Status as of last Weekly Progress Report 3/9/16 immediately following termination of steam injection

ST12 Steam Enhanced Extraction: Has criteria for termination of Steam Injection Been Met?

Figure 28. NAPL Screening Results and Calculated Benzene Concentrations - Upper Water Bearing Zone

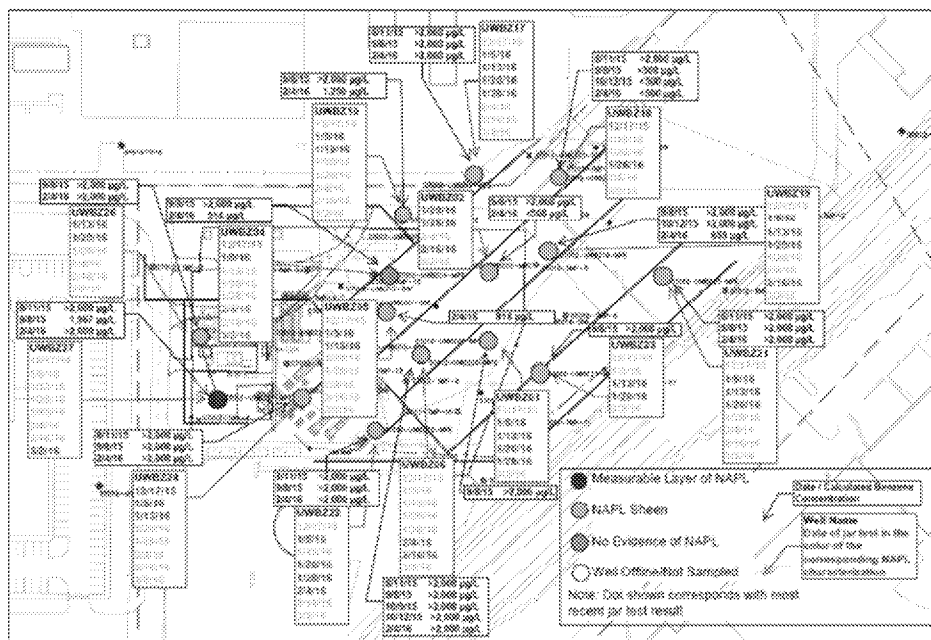
## Benzene Concentrations in UWBZ exceed 500 µg/L; Still removing LNAPL, Criteria has not been met for UWBZ

Figure 4. Daily Mass Removed

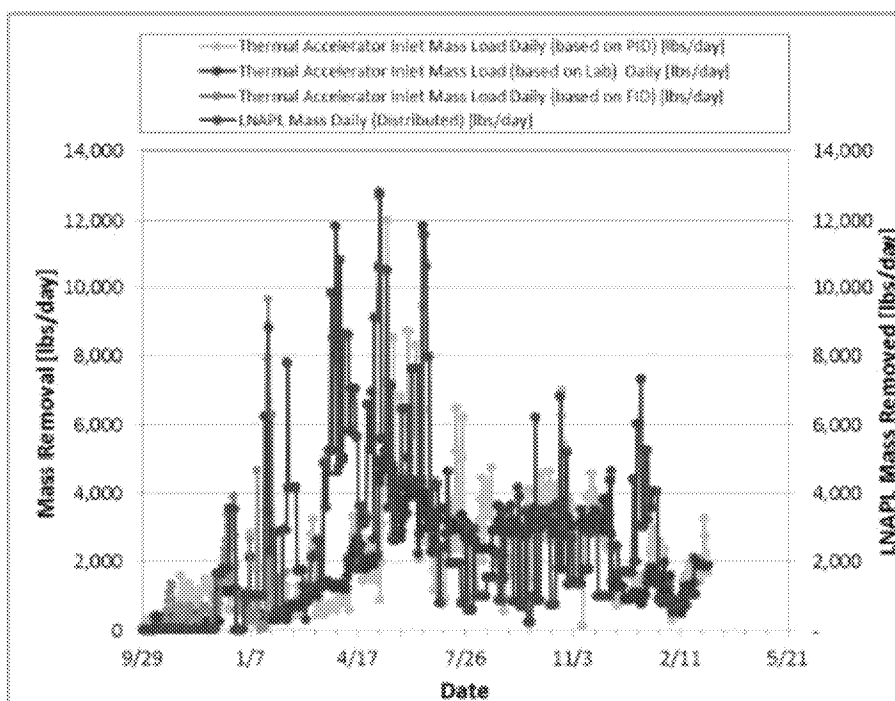
**Analysis:** Vapor recovery alone was at 16% of peak removal rate; Criteria for termination of steam injection has not been met. LNAPL recovery not calculated at the time of the report as it was only reported when sufficient quantity accumulated to transfer to holding tank.

Mass Removal over Time

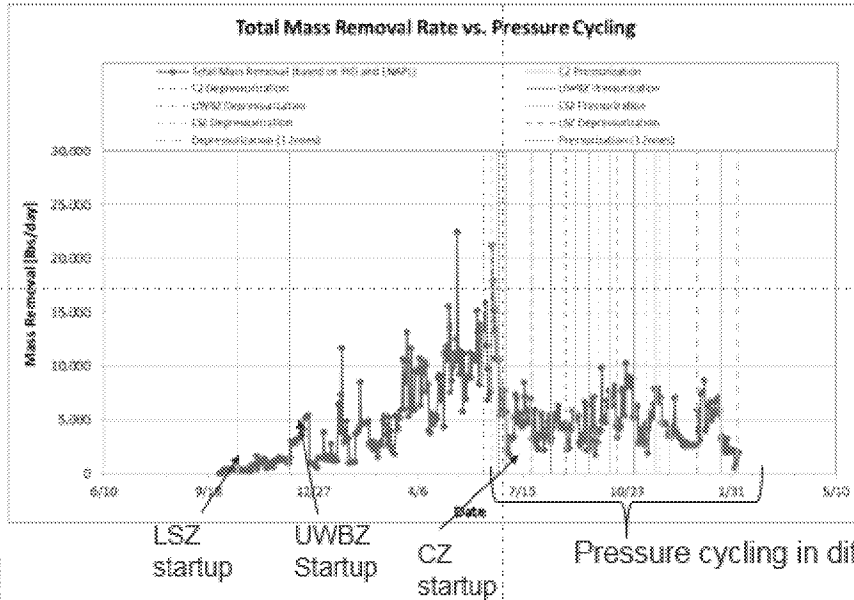
*NAPL Recovery was increasing up until the time pressure cycling was initiated. Did decline in recovery rate occur because pressure cycling was initiated early? Consider the analogy of liquid recovery with pressure cycling similar to turning spigot of garden hose on and off....*

Extracted Vapor Benzene Concentrations over Time

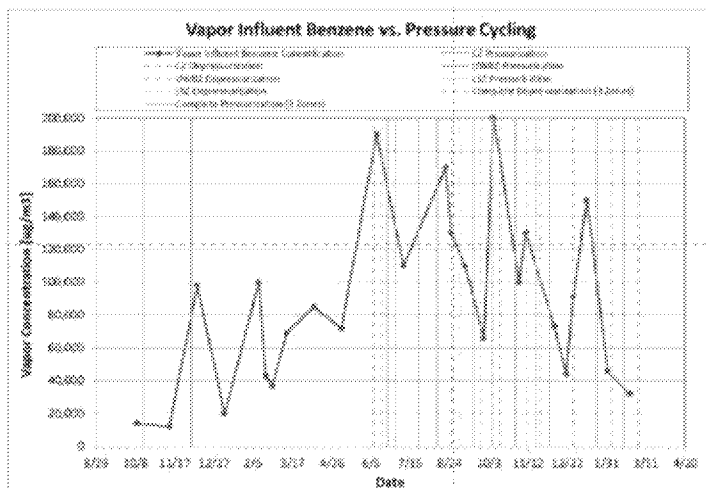
*The criteria in the RD/RAWP stating that “the process is repeated . . .until no additional significant increases in effluent vapor phase concentrations occur when steam pressure is reduced” has not been met.*

*Extracted Liquid Benzene Concentrations over Time (measured at air stripper influent by EPA Method 8260B)*

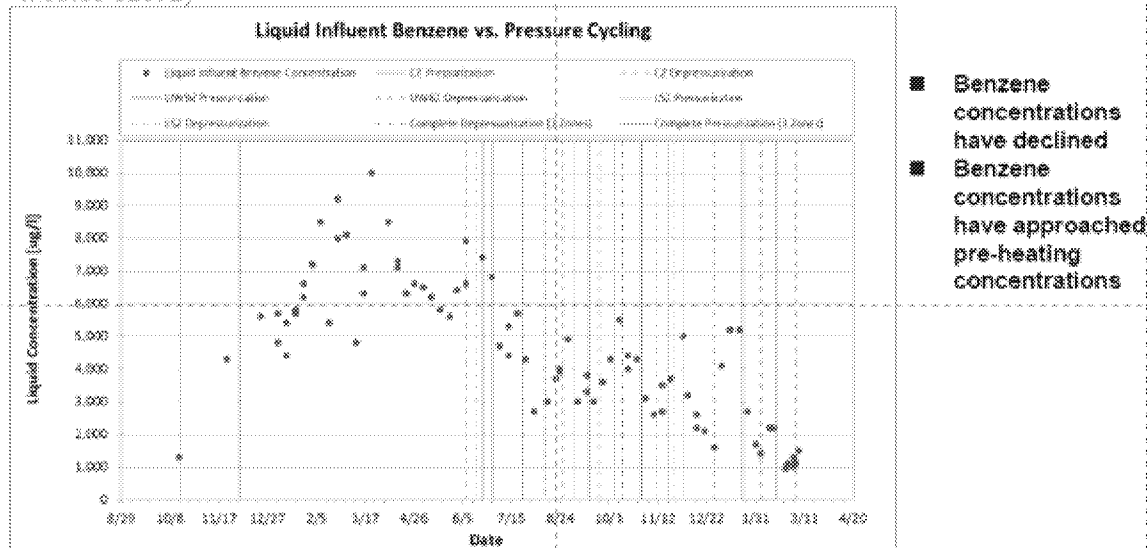
*Concentrations of benzene recovered in air stripper effluent were declining but still above 1000 ppb indicating significant recovery still taking place.*

Figure 6. Average Soil Temperatures

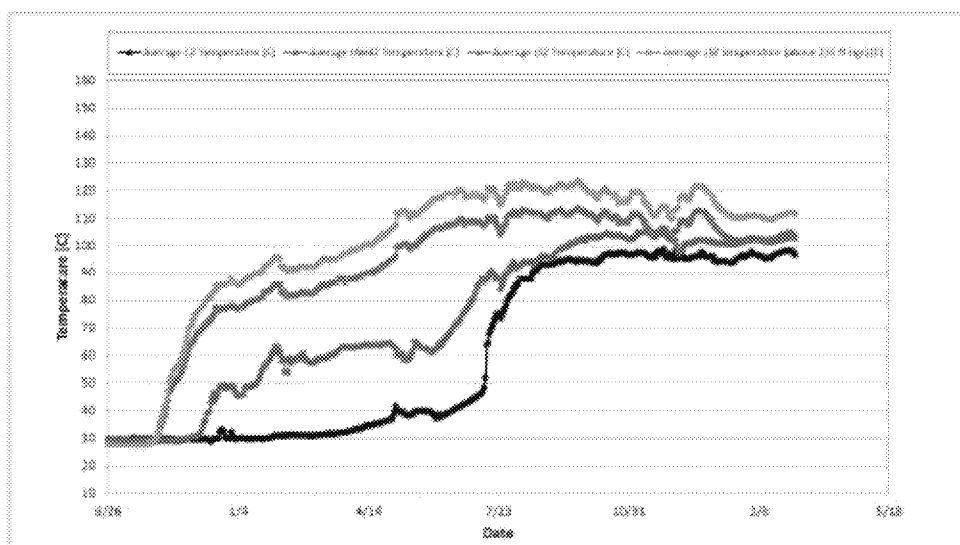
*We generally concur that Steam temperature criteria has been met.*
